# Agenda Item # 9

## SUB-002894-2024

Gaillard Oaks Subdivision, Resubdivision of Lot 4

APPLICATION NUMBER 9 DATE April 18, 2024

# DETAIL SITE PLAN

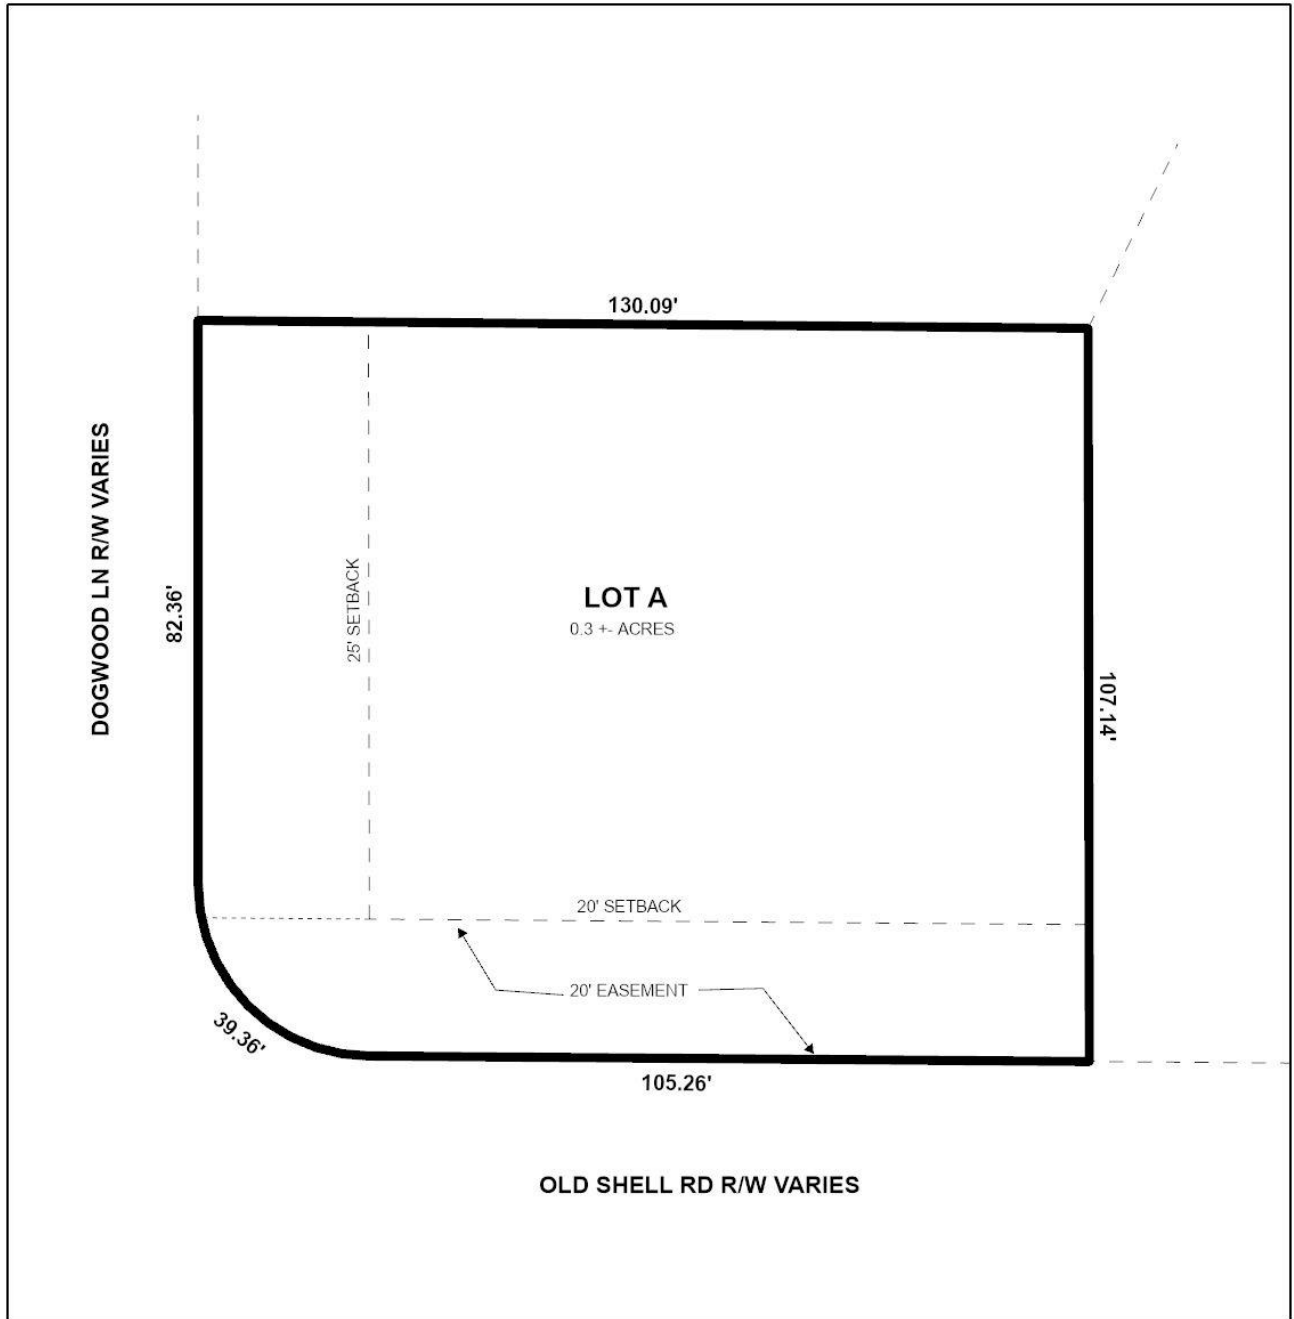
The existing lot has frontage along Dogwood Lane and Old Shell Road, with a recorded 25-foot minimum building setback line along both streets. The applicant proposes to construct an addition onto the existing garage which would encroach into the recorded setback along Old Shell Road to within approximately 20 feet of the right-of-way line. This subdivision request is to amend the recorded 25-foot setback along Old Shell Road to 20 feet. As there is a recorded non-exclusive reciprocal easement for ingress and egress along the Old Shell Road (South) side of the property, the minimum building setback along that side cannot be reduced to less than 20 feet.

The preliminary plat indicates that both Old Shell Road and Dogwood Lane have variable right-of-way widths. As Gaillard Oaks Subdivision did not require dedication along these street frontages, no required dedication would seem in order for the current subdivision request. Gaillard Oaks was recorded with a compliant 25-foot corner radius curve at the intersection of the two streets. The right-of-way widths of both streets should be retained on the Final Plat, if approved.

The proposed lot exceeds the minimum size requirement of the Subdivision Regulations, and the lot size label in both square feet and acres should be retained on the Final Plat, if approved, or a table should be furnished on the Final Plat providing the same information.

As the site contains a recorded easement, the note on the preliminary plat stating that no structure shall be constructed or placed within any easement without the easement holder's permission should be retained on the Final Plat, if approved.

The site is within an R-1, Single-Family Residential Suburban district, which allows five-foot (5') minimum side street yard setbacks. Therefore, the requested 20-foot (20') minimum building setback line would be within the allowable limits.

1. Retention of the right-of-way widths of Old Shell Road and Dogwood Lane on the Final Plat;
2. Retention of the lot size label in both square feet and acres on the Final Plat, or the furnishing of a table on the Final Plat providing the same information;
3. Retention of the note on the Final Plat stating that no structure shall be constructed or placed within any easement without the easement holder's permission;
